**RITE AID 7 X 7 PYLON  
W/ 5 X 7 READERBOARD**  
ELECTRICAL LOAD:  
9.7 AMPS @ 120 VOLTS  
ELECTRICAL REQUIREMENTS:  
(1) 20 AMP/120 VOLT CIRCUITS

<p>Philadelphia Sign Company 707 West Spring Garden Street Palmyra, New Jersey 08065-1798</p>	TITLE: RITE AID 7 X 7 PYLON SIGN W/ 5 X 7 READERBOARD		JOB NO.:		REV.	DATE	DESCRIPTION
	LOCATION: VARIOUS		SHEET NO: 1 OF 3		2	12-26-96	CHANGED COLOR OF JDM READER BOARD TO BLACK
	DRAWN: KJH	CK. BY:	DWG. NO: B-2357	REV. 1	1	12-12-96	ADDED PG#1 KJH
	DATE: 12/12/96	LO#

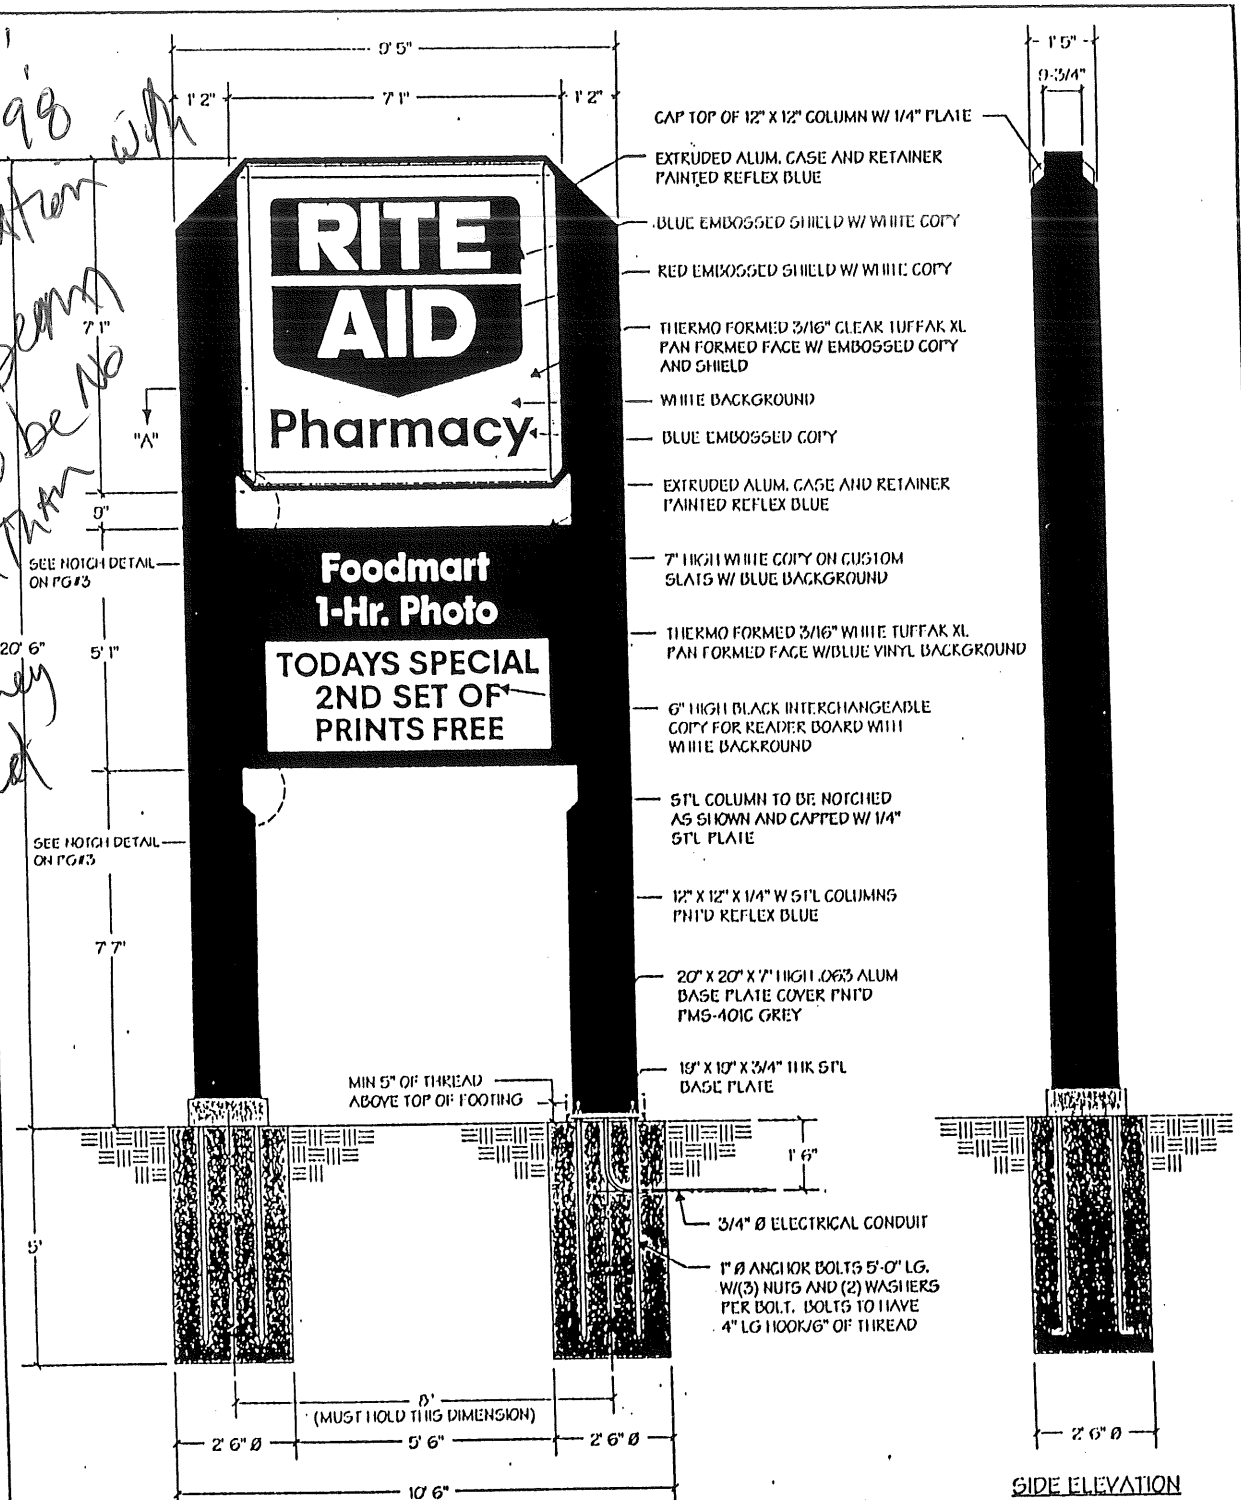
*Note: A/15/98 conversation with Rod Berman. Sign to be higher than No 101 - they agreed.*
